# Addendum to Geotechnical Investigation Report

Peacockes Road

Hamilton

20.02.2019 14280.000.000\_23

Harrison Grierson Stormwater Detail Plan Sheets 1 & 2

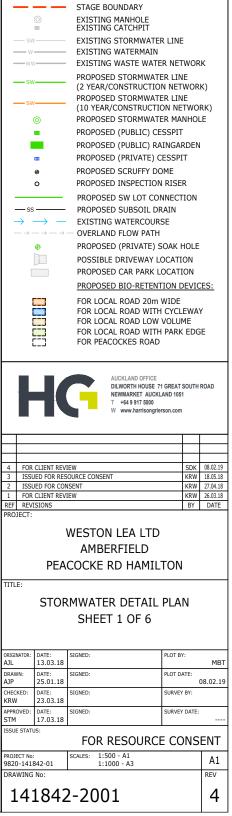
Minor changes to the extent of additional counterfort drainage required on site have also been incorporated into the revised site model. See Harrison Grierson (HG) Stormwater Detail Plan Sheets 1 and 2, reference 141842-2002 Rev 4 dated 08/02/2019 attached.

The requirement for additional drainage within two areas in the north-eastern portion of the site (as previously noted within the GIR) remains. The revised extent of these drains is shown in the HG Stormwater Detail Plan Sheets appended.
